Eck 10th Addition

RE: SUB 2001-81-- Final Plat of Eck Tenth Addition

REVISED STAFF REPORT

CASE NUMBER: SUB 2001-81 -- ECK TENTH ADDITION

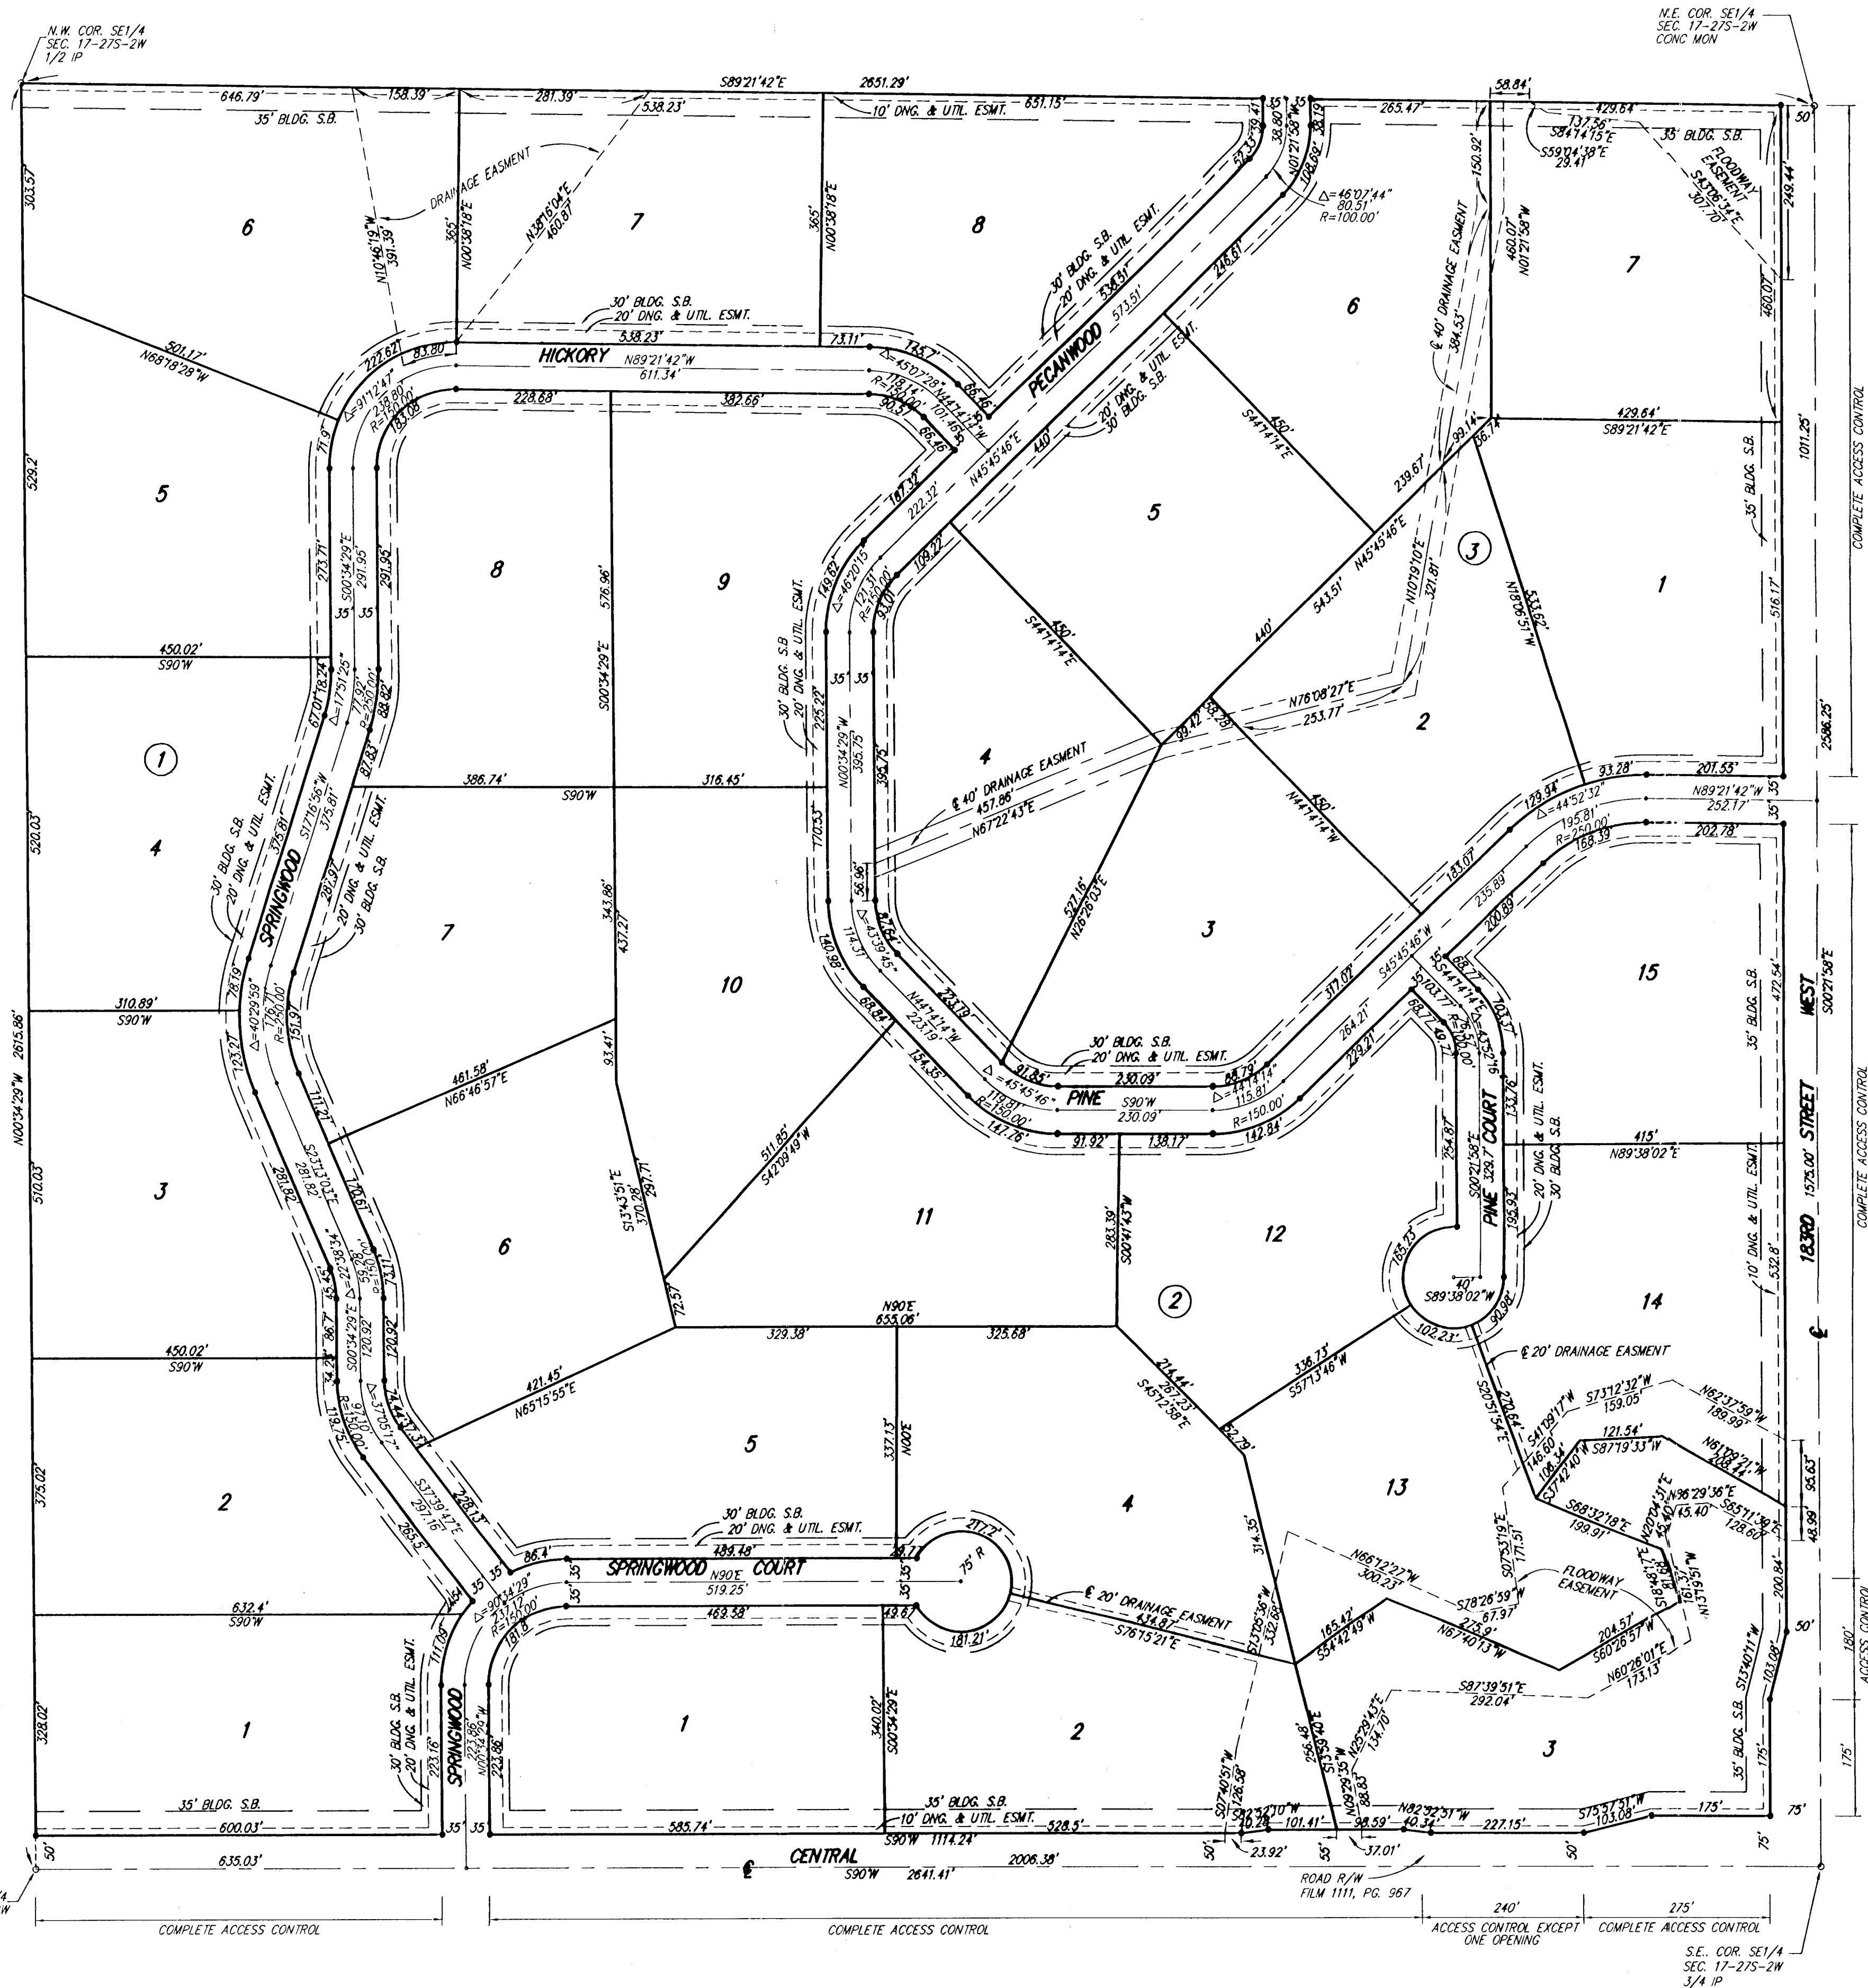
- E. County Engineering needs to comment on the status of the applicant's drainage plan. **Floodway reserve boundaries need to be reviewed. Adjustments to floodway reserves may be required after review of the drainage plan. Minimum pads may be required. Development on Lot 6, Block 1, and Lots 2,3,4,13,14, Block 2, needs to be restricted prior to a letter of Map Revision from FEMA. Drainage easements may need to be increased. A Master Lot Grading Plan is needed.**

- F. County Engineering has required complete access control to 183^d West for Lot 7, Block 3; access may be obtained from Willow Creek Drive.

- I. The County Fire Department/GIS needs to comment on the plat's street names. GIS has required Autumn Drive be revised to Springwood; extending from the south line of the plat to include the frontage of Lot 5, Block 1. Autumn Drive Ct shall be revised to Springwood Ct. Pecanwood Road shall be revised to Pecanwood extending from the north line of the plat to include the frontage of Lot 10, Block 2. Pine Road shall be revised to Pine.

- GIS has requested the removal of the street names denoted on the abutting property to the north.
- J. Lot 13, Block 2 does not meet the 200-ft lot width requirement which is measured at the building setback line. The lot also does not meet the 100-ft lot frontage requirement. A modification will need to be approved. The Subdivision Committee has approved a modification.

- M. The floodway reserve near the southeast corner of plat needs located with respect to property lines.
- N. On the final plat tracing, the MAPC signature block needs to reference "J.D. Michaelis, Chair".

- O. The platator's text shall include language that a drainage plan has been developed for the plat and that all drainage easements, rights-of-way, or reserves shall remain at established grades or as modified with the approval of the applicable City or County Engineer, and unobstructed to allow for the conveyance of stormwater.

The requested access controls have been platted.
